# DDA ASSESSMENT REPORT

New Primary School at Gregory Hills  
28 Wallarah Circuit, Gregory Hills NSW 2557

Prepared for: SINSW | Issue date: 5 October 22

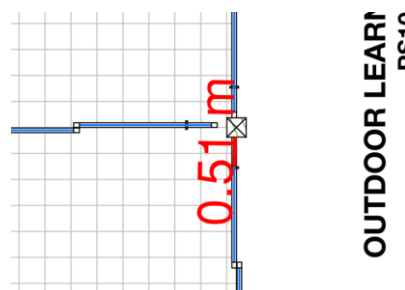
- Doorways within Blocks A and B were typically noted as being scaled at 750mm – 800mm. As this building is required to be accessible, all doorways are required to be a minimum 850mm wide. Architect to note and ensure this detail is provided in the next iteration of design.

- Inadequate latchside door circulation spaces were noted in a few locations to be less than 510mm (when door is swinging away from the user) and 530mm (when the door is swinging towards the user). Architect to note the below locations and ensure that all door circulation spaces comply with the relevant requirements of AS1428.1-2009

Architect to note that door hardware is to be a minimum 530mm out from any internal corner.

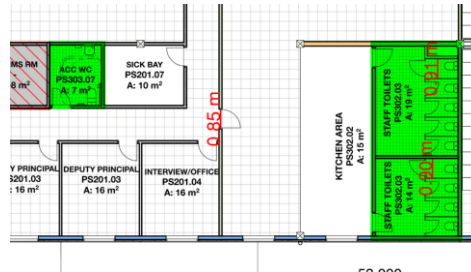
- Doorways within Blocks A and B were typically noted as being scaled at 750mm – 800mm. As this building is required to be accessible, all doorways are required to be a minimum 850mm wide. Architect to note and ensure this detail is provided in the next iteration of design.

- Inadequate latchside door circulation spaces were noted in a few locations to be less than 510mm (when door is swinging away from the user) and 530mm (when the door is swinging towards the user). Architect to note the below locations and ensure that all door circulation spaces comply with the relevant requirements of AS1428.1-2009

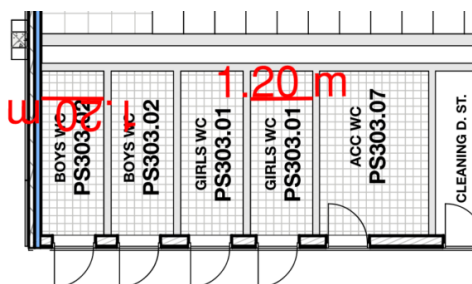
Proposed ambulant sanitary facilities (PS303.02 and PS303.01) in Block C were dimensioned at 1.2m in width. Architect to note that ambulant sanitary facilities are required to be between 900-920mm between side walls. Architect to note and amend the plans accordingly.

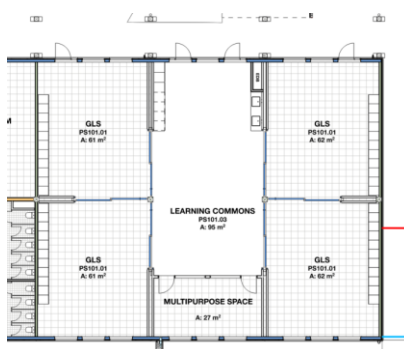
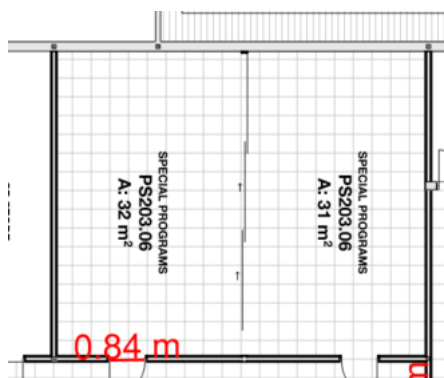
Additionally, the ambulant sanitary facilities in building B were typically dimensioned at 980mm between side walls in lieu of 900 – 920mm. Architect to note and amend the plans accordingly.

Architect to furthermore note that proposed ambulant sanitary facilities blocks within Block A were typically dimensioned at 1200mm in lieu of 900mm-920mm as per the requirements of AS1428.1-2009
